MWO 9-2320-272-20-6

FUEL TANK VENTILATION KIT
MODIFICATION WORK ORDER

MODIFICATION OF 5-TON
M939 AND M939A1 SERIES TRUCKS

FIGURE 8

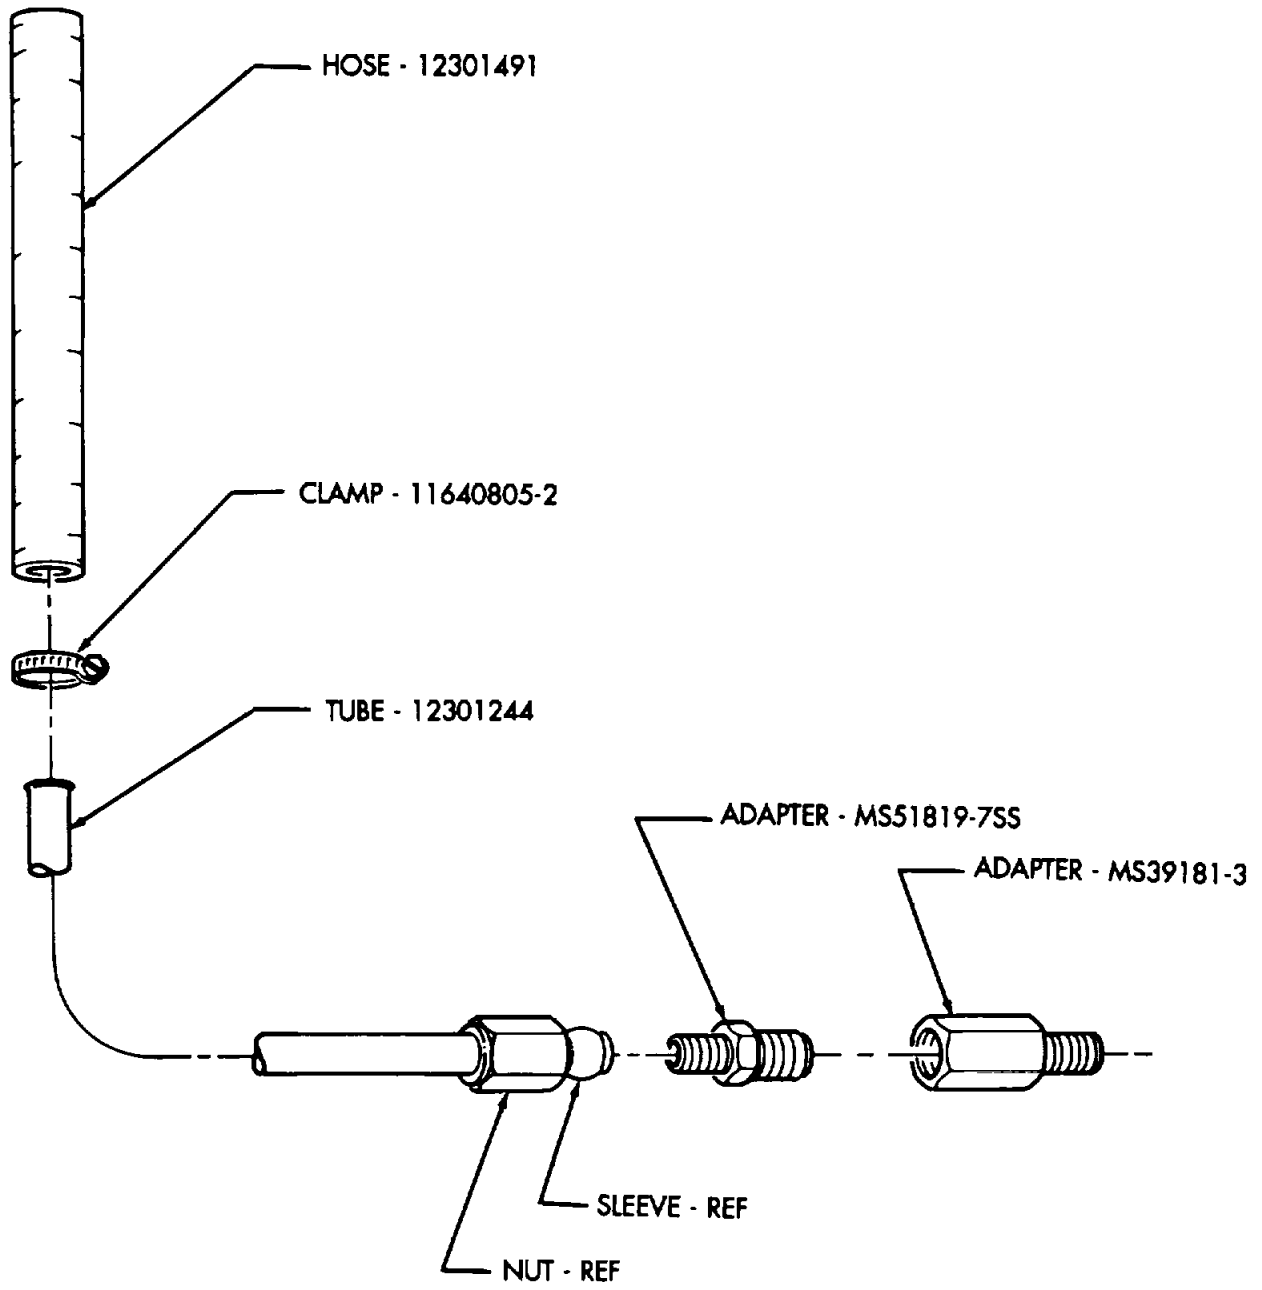
- (9) Install nut, sleeve, and MS51819-7SS adapter on 12301244 tube as shown in figure 8.
- (10) Install tube and adapter on MS39181-3 adapter as shown in figure 8. Retain sleeve and nut for use in step 12.

- (11) Install 12301491 hose on tube with 11640805-2 clamp as shown in figure 8.
- (12) Install two nuts and sleeves from adapters removed in steps 8 and 10 on CPR104420-2 tubing as shown in figure 9.

FIGURE 9

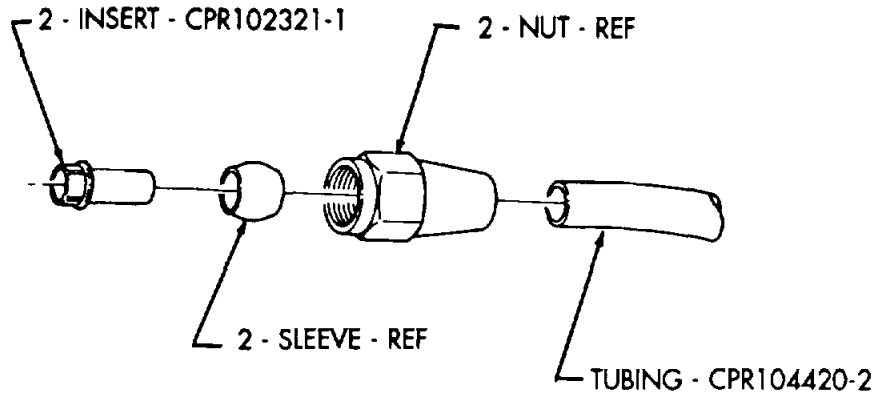
- (13) Install CPR102321-1 inserts in each end of fuel tank vent line as shown in figure 9.

FIGURE 10

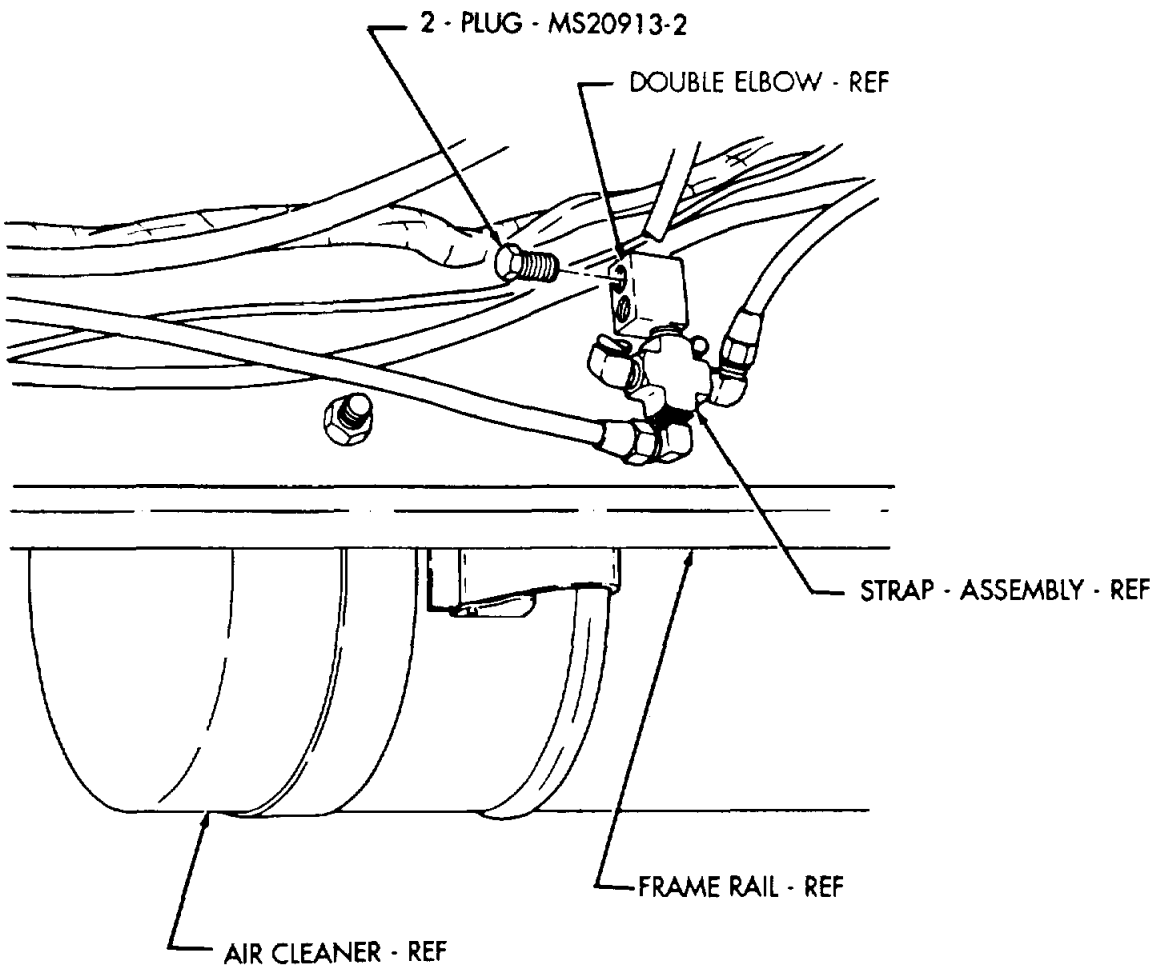
- (1) Install two MS20913-2 plugs in double elbow on strap assembly located inside of frame rail opposite air cleaner as shown in figure 10.
- (2) Install tee assembly on frame rail with MS90726-114 screw and MS51943-40 nut as shown in figures 6 or 7.

FIGURE 11
18

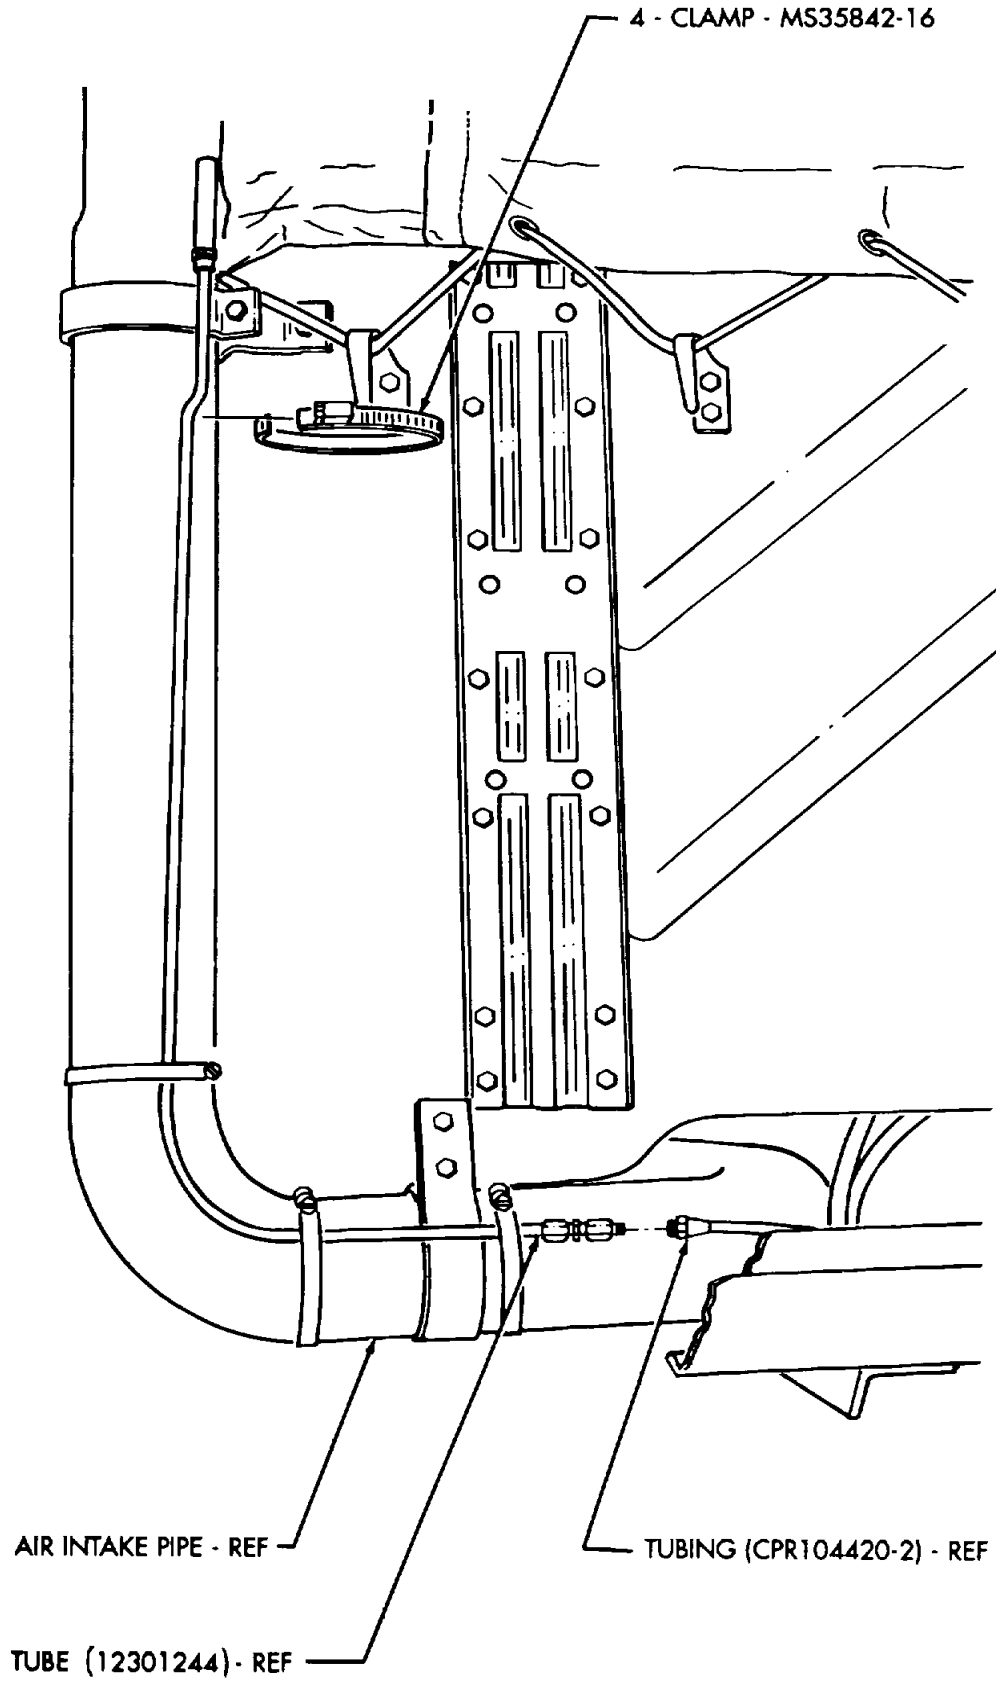
- (3) Connect two fuel tank vent lines from fuel tank-to-tee assembly as shown in figure 6.
- (4) Connect four fuel tank vent lines from fuel tanks-to-tee assembly as shown in figure 7.
- (5) Connect end of CPR104420-2 fuel tank vent line to tee assembly (12301228) as shown in figures 6 or 7.
- (6) Install tube (12301244) on air intake pipe with four MS35842-16 clamps as shown in figure 11. Remove excess clamp ends.
- (7) Connect end of fuel tank vent tubing (CPR104420-2) to tube (12301244) as shown in figure 11.

FIGURE 12

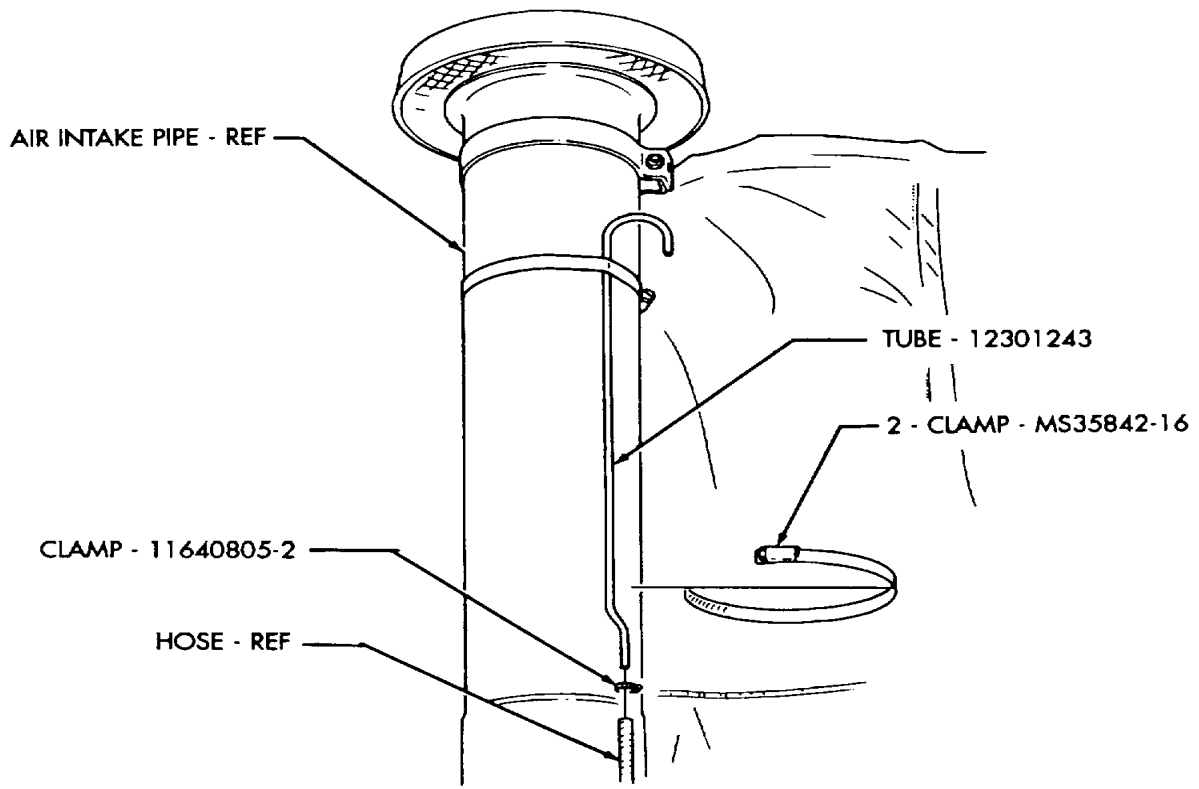
- (8) Install 12301243 tube on hose with 11640805-2 clamp as shown in figure 12.
- (9) Install tube on air intake pipe with two MS35842-16 clamps as shown in figure 12. Remove excess clamp ends.

FIGURE 13

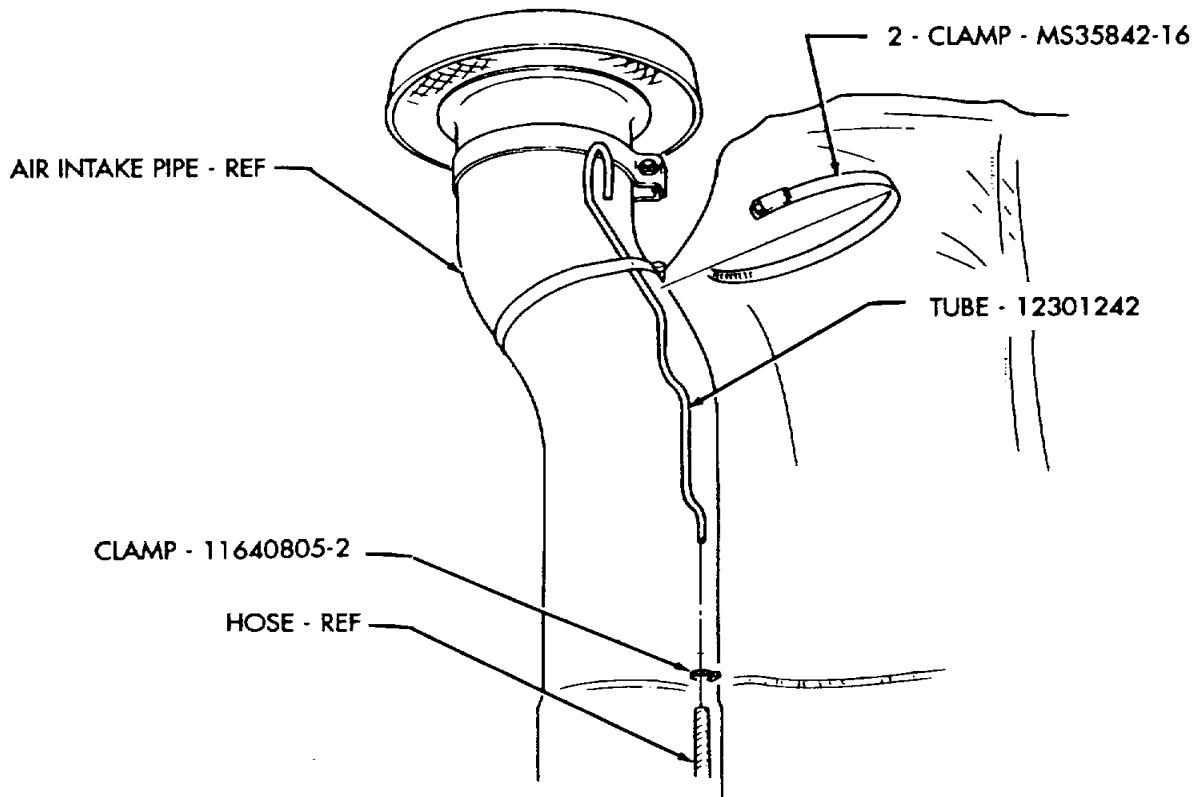
- (10) Install 12301242 tube on hose with 11640805-2 clamp as shown in figure 13.
- (11) Install tube on air intake pipe with two MS35842-16 clamps as shown in figure 13. Remove excess clamp ends.

FIGURE 14

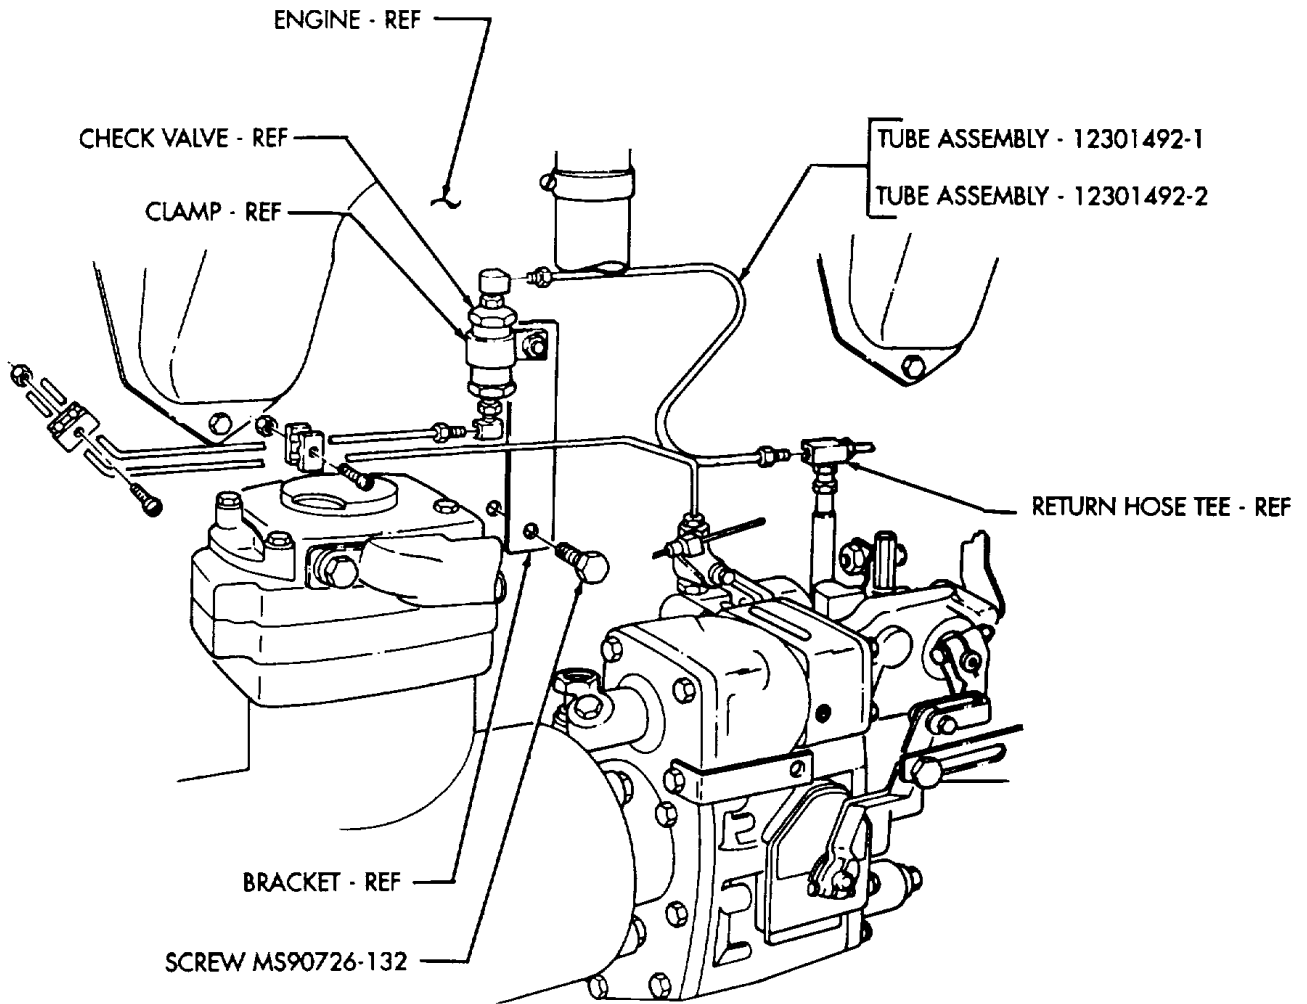
- (1) Install bracket with check valve on engine with MS90726-132 screw as shown in figure 14.

- (2) Connect 12301492-2 tube assembly to check valve and fuel return hose tee as shown in figure 14.
- (3) Connect 12301492-1 tube assembly to check valve and fuel return hose tee as shown in figure 14.
- (4) Connect 12301493 tube assembly to elbow on front of engine and check valve as shown in figure 15.
- (5) Install two clamps on tube assembly and fuel supply line with two screws and nuts as shown in figure 15.

FIGURE 16

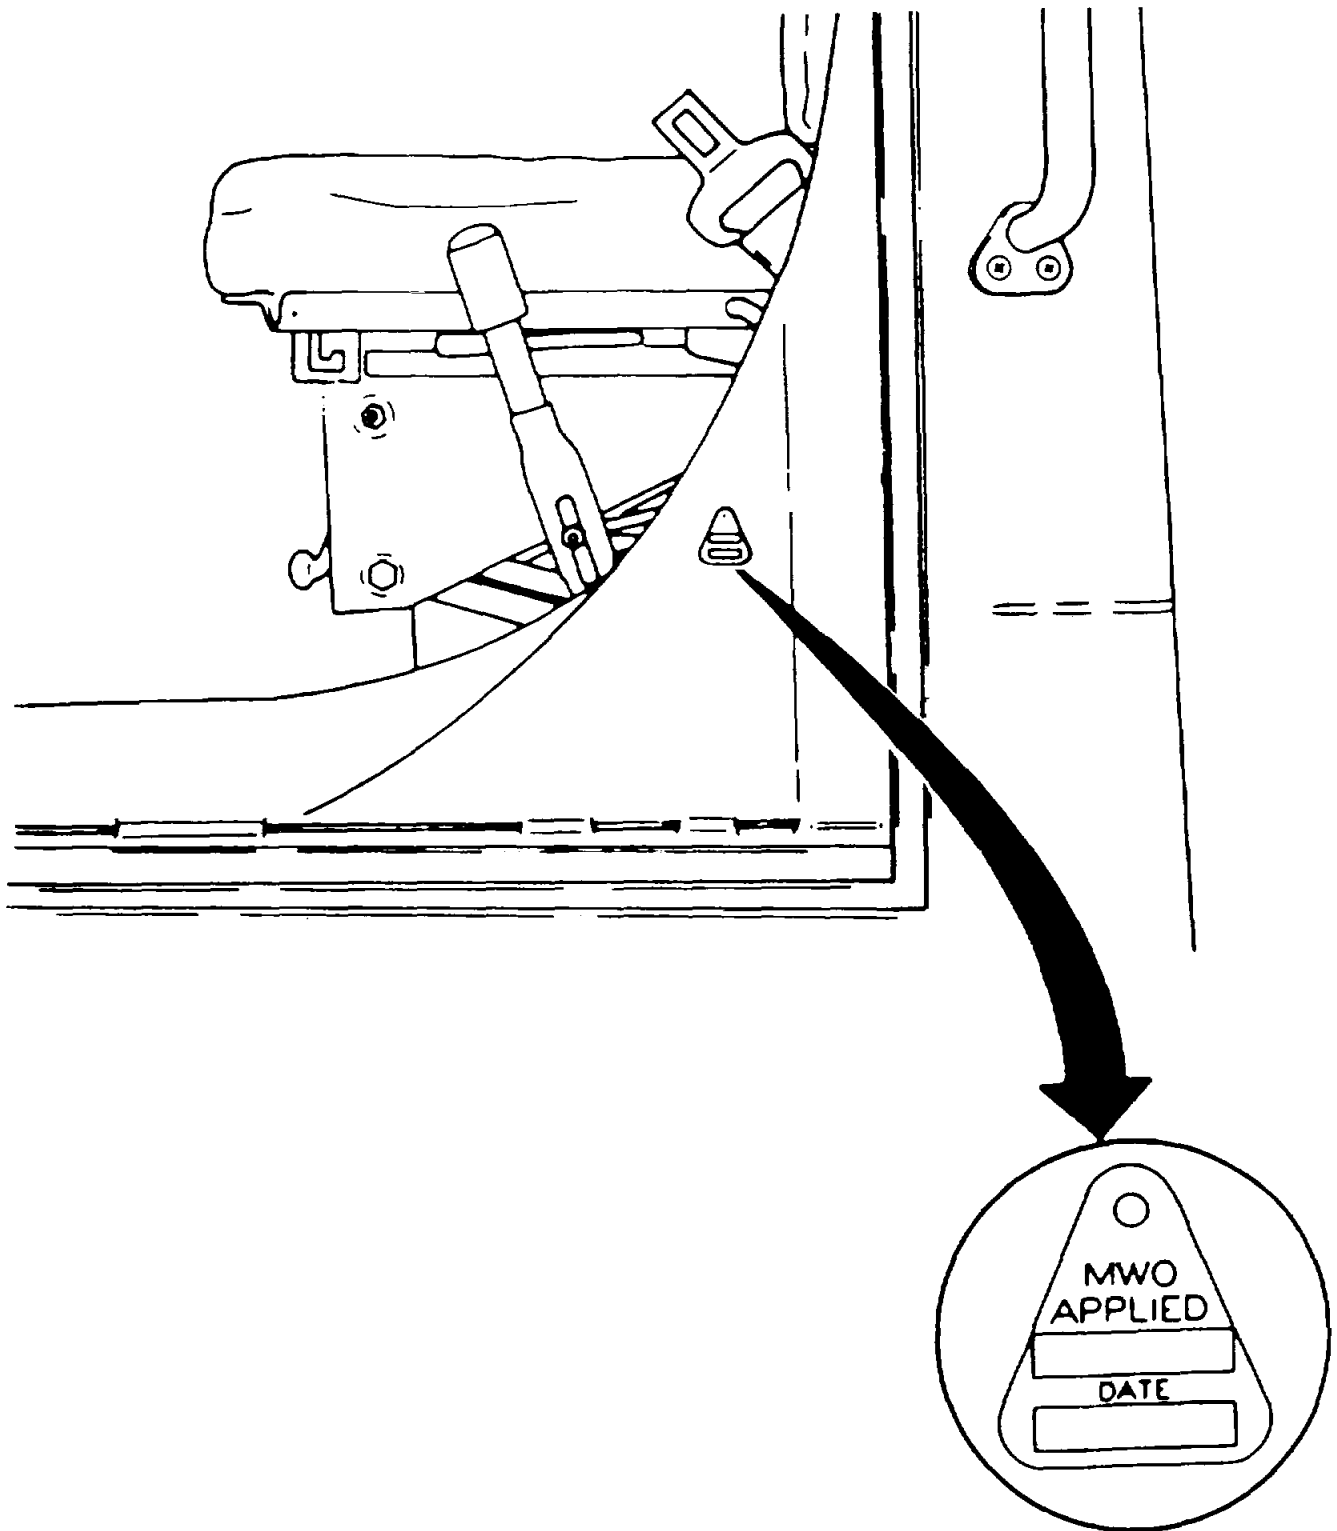
- (1) After Fuel Tank Atmospheric Vent System Kit is installed, mark MWO number "9-2320-272-20 6" in the MWO applied block and date applied in date block on MWO Instruction Plate NSN 9905-00-858-5682.
- (2) Install MWO data plate by drilling a hole (#37 drill) in cab body reinforcement panel and secure with drivescrew NSN 5305-00-253-5614 as shown in figure 16.
- (3) After drivescrew is installed, flatten or remove protruding excess drivescrew material from inside of cab body reinforcement panel.

When the Fuel Tank Atmospheric Vent System Kit is installed, it will be identified by the MWO Instruction Plate mounted on the cab body reinforcement panel as shown in figure 16.
